## DESIGN COMMISSION REGULAR MEETING AGENDA

#### Agenda Item #1: DSR2017-023: Qdoba Sign Design Review

### CITY OF MERCER ISLAND DESIGN COMMISSION STAFF REPORT

Project:	DSR17-023 – Design review for four proposed signs for a restaurant within the Mercer Building in Town Center
Description:	A request for design review approval of 1) one new illuminated wall sign, 2) one new illuminated projecting sign, 3) replacement of an existing tenant panel in a joint business directory, and 4) one new indoor illuminated hanging sign at The Mercer building in Town Center
Applicant:	Stefanie Lindquist (Meyer Sign)
Site Addresses:	7650 SE 27 <sup>th</sup> St #106 Mercer Island, WA 98040; Identified by King County Tax Parcel # 531510-1491
Zoning District:	Town Center (TC)
Exhibits:	<ol> <li>Project Narrative prepared by Meyer Sign, submitted Jan. 3, 2017</li> <li>Plan set by PM Design, dated Jun. 29, 2017</li> <li>Development Application signed Oct. 25, 2017</li> <li>Sign Diagram from the Gateway Commons design approval, dated November 6, 2002.</li> </ol>

## ELEVATIONS

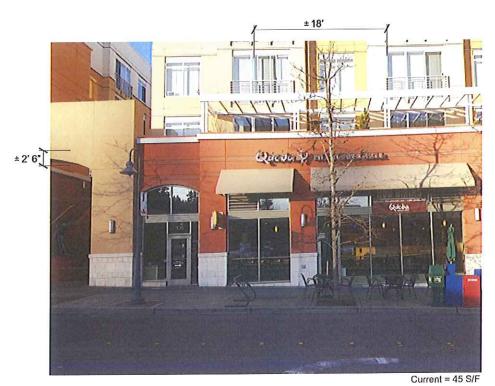
**<u>Staff Analysis</u>**: The proposed wall sign is proportionate to the size of the restaurant's frontage (Exhibit 2)

<u>Staff Analysis</u>: The total combined area of the wall sign's individual letters and symbols is 24.7 sq ft (Exhibit 1). This standard is met.

<u>Staff Analysis:</u> The wall sign is proposed to be placed below the windowsill of the second story, consistent with this standard (Exhibit 2).

## ELEVATIONS

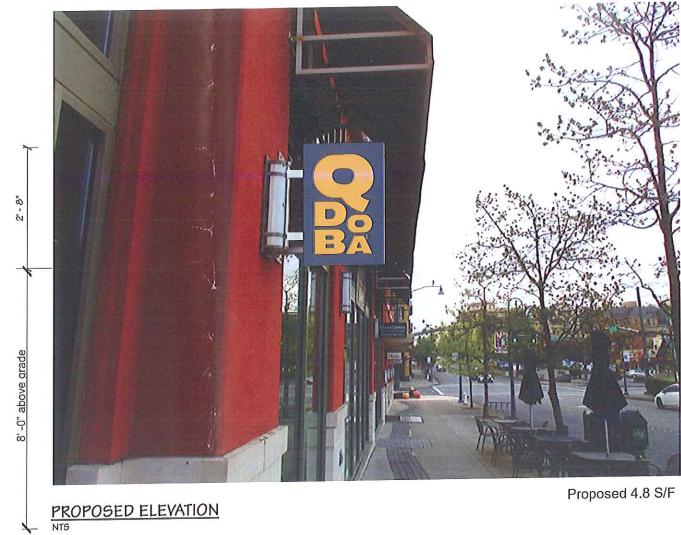
**<u>Staff Analysis:</u>** The proposed projecting sign's bottom edge will be 8 feet above grade (Exhibit 2), meeting this standard.

**<u>Staff Analysis:</u>** The proposed projecting sign will be approximately 4.8 square feet (Exhibit 2), meeting this standard.

**<u>Staff Analysis:</u>** The proposed sign will project 2 feet 3.5 inches from the building, meeting this standard (Exhibit 2).

## **TENANT PANELS**

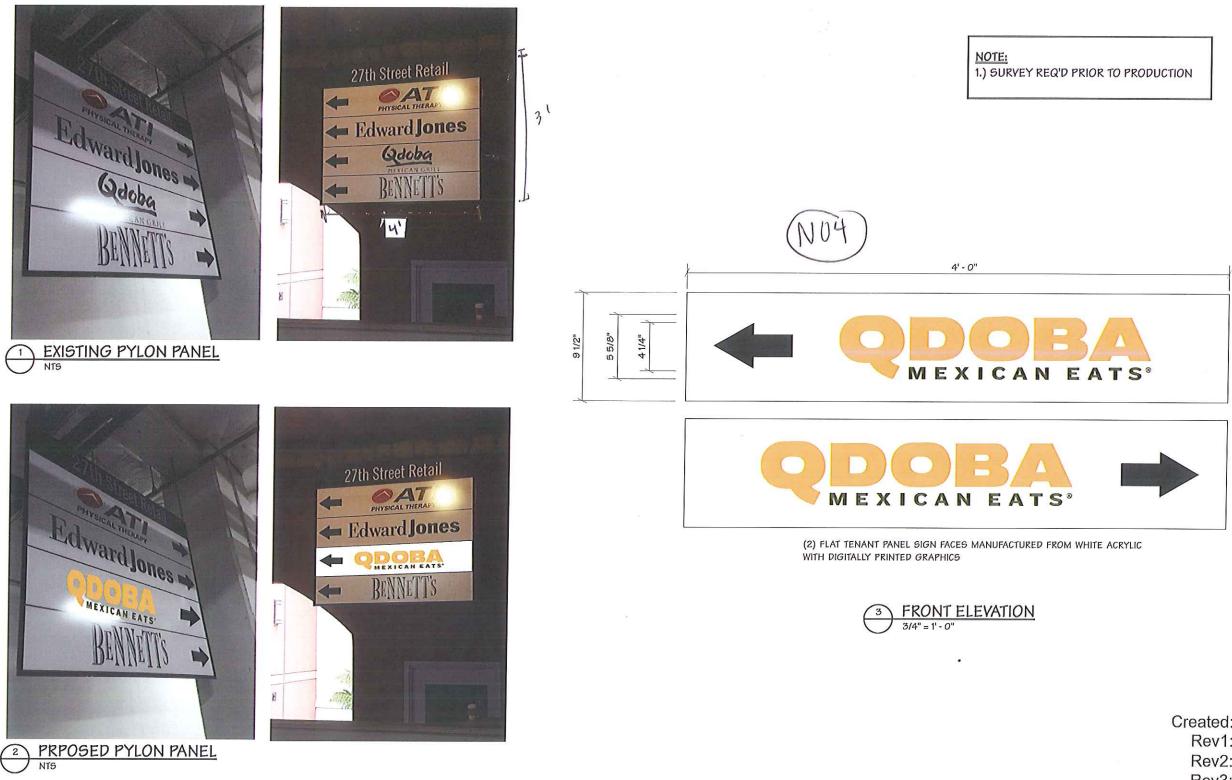
<u>Staff Analysis</u>: The replacement tenant panel is part of an existing joint business directory sign inside the Mercer Building. The joint business directory sign is 12 sq ft (Exhibit 2), and no change in the overall size is proposed. Only the tenant panel is being replaced. This standard is met.
